# Product Change Notification PCN No: 2006-08-22-01 Report Date: August 22, 2006 Subject: LK404-25 PCB 2.0 New Board Revision Release

LK404-25 PCB 2.0 including all applicable extensions and combinations

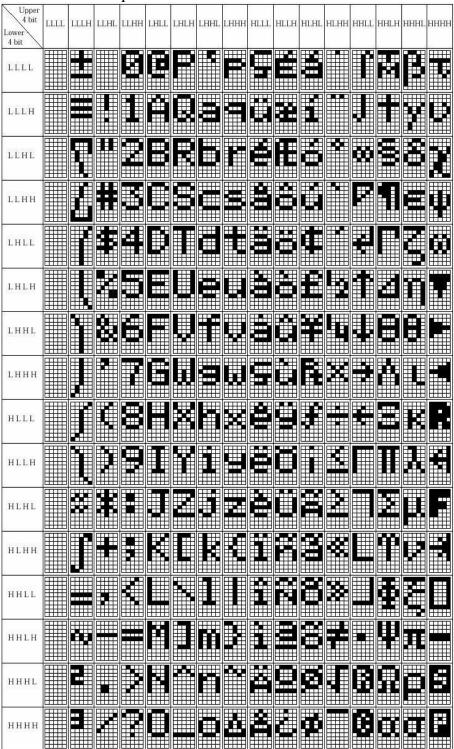
1) The 5x11 matrix style keypad connector has now been changed to 5x5. Aside from the number of connections, the differences between the revisions are:

- physical placement of the connectors has been standardized across all

our products

- PCB 2.0 offers additional grounding and grounding or 5V (selectable) pins on the keypad connector, hence there are 12 pins on the keypad connector

- Both old and new PCB have the same column and row layout such that the middle pins on the board are row 5 and column 1. Since there are only now a total of 25 possible keys instead of 55, the values that are transmitted by PCB 2.0 starts from 'A' to 'Y' (the old PCB used to have 0x08 to 0x3E). Please see the manuals (PCB 1.3 versus PCB 2.0) for comparison.

- PCB 2.0 have improved ESD protection on the keypad connectors with incorporated resistors.
